TOWN OF LOS GATOS
PLANNING COMMISSION STAFF REPORT
Meeting Date: August 22, 2012

APPLICATION NO: Architecture and Site Application S-12-038

LOCATION: **236 & 238 Bachman Avenue** (north side of Bachman Avenue,
between Tait and Wilder Avenues)

APPLICATION SUMMARY: Requesting approval to demolish a two-family dwelling, and construct a single-family dwelling with a detached garage with reduced rear setbacks on property zoned R-1D:LHP. APN 510-14-054.

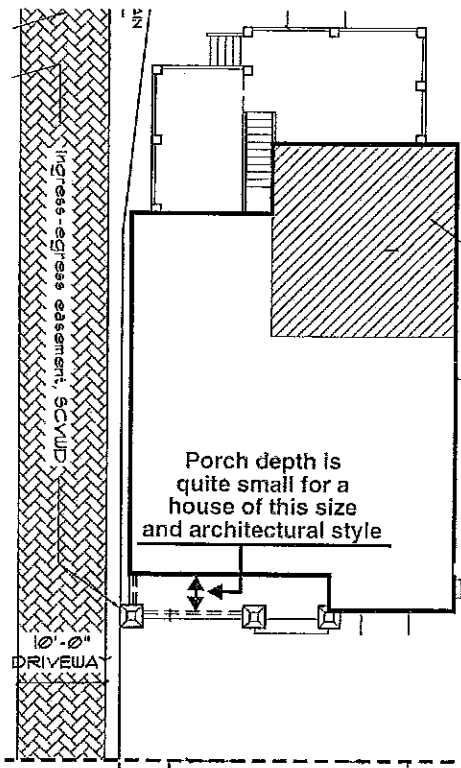
1. The front entry porch depth is quite small for a house of this size and architectural style. The clear depth is below the absolute minimum called for in the *Town's Residential Design Guidelines*. The porch depth should be revised to be a minimum of 6 feet clear, and arguably, it should be larger - up to 8 feet in depth - given the size and style of the proposed house.

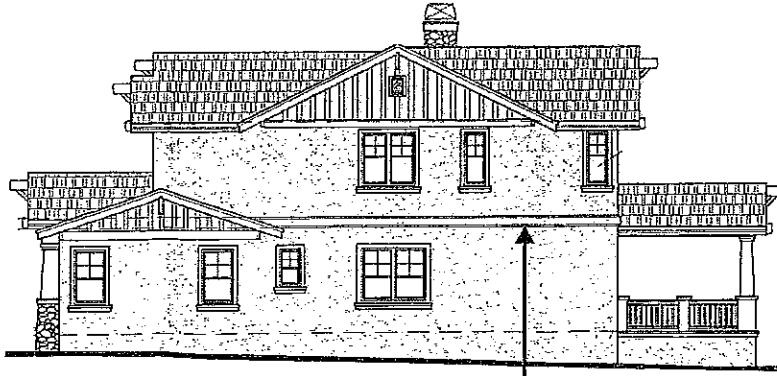
2. The trim band at the second floor appears from the texture on the drawings to be stucco. This would be unusual and inappropriate to the authenticity of the architectural style. It should be wood.

**This trim band appears to be stucco which would
be very unusual for this architectural style**
Use wood trim

TREE MAP

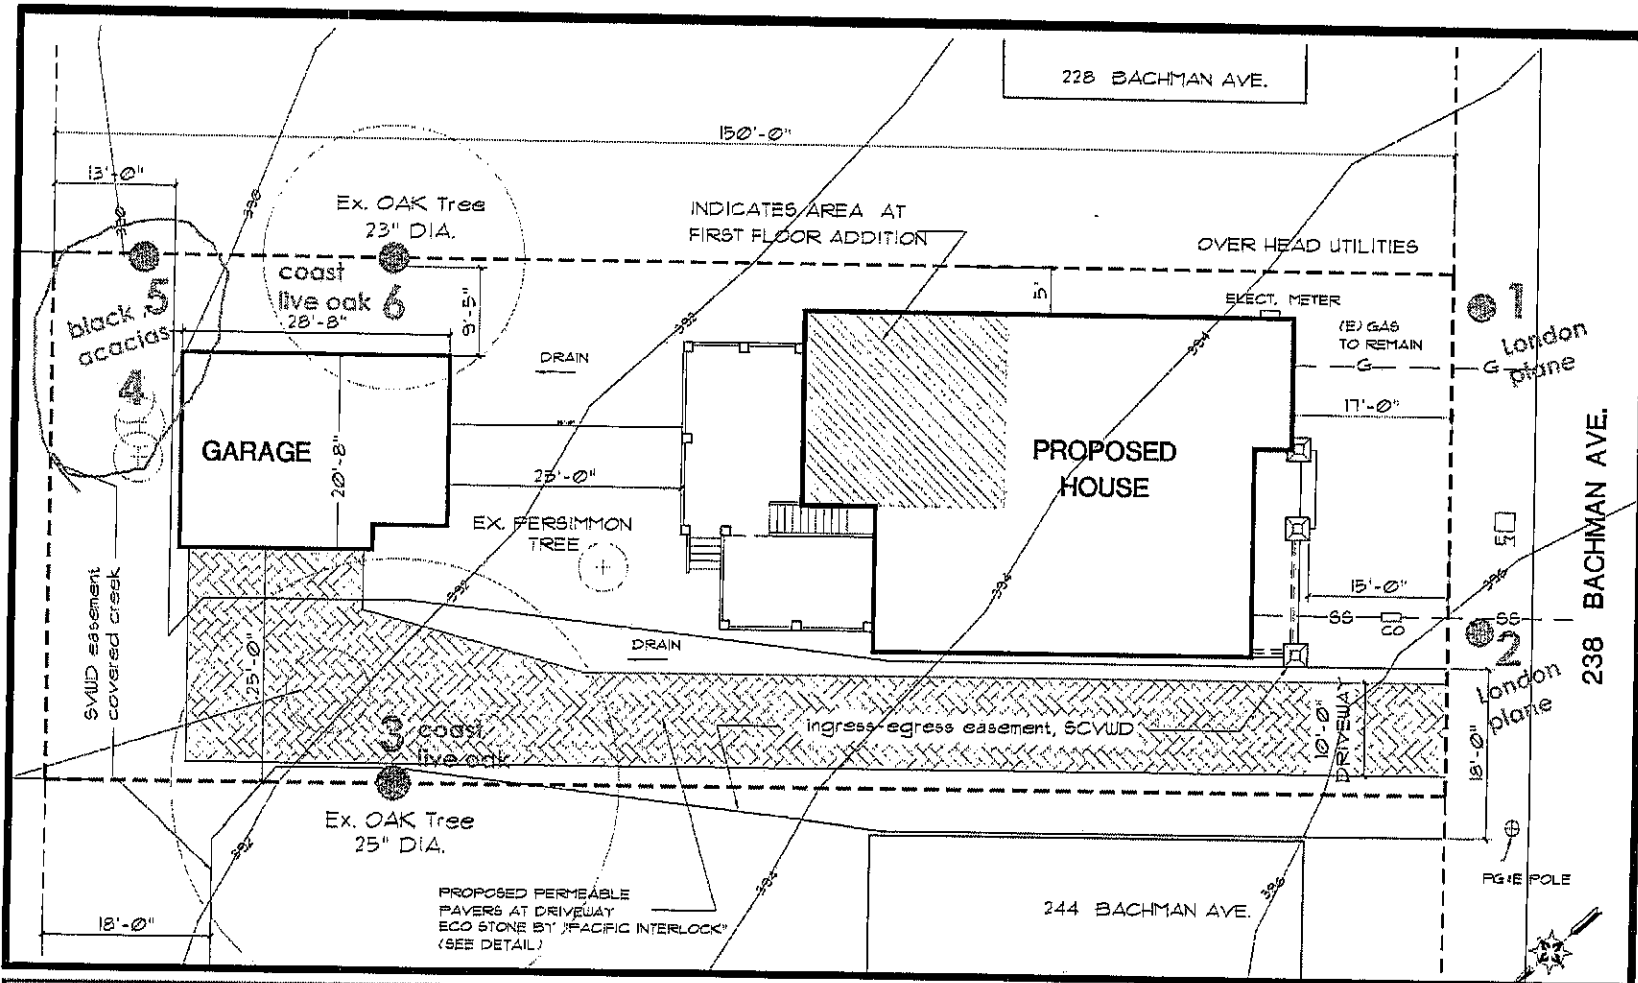
- 1) **Accurately survey and include the locations of trees #1, 2 and 5 on the site plan.** Accurately delineate the area that includes the many trunks of black acacia suckers that I have labeled as #4. Show the accurate driplines of all trees on site accurately as well.

- 2) **Clarify if the sewer line adjacent to London plane tree #2 is proposed or existing.** If proposed it must be tunneled or air-spade³ excavated if the excavation will be 4 feet or less from the trunk of the tree.
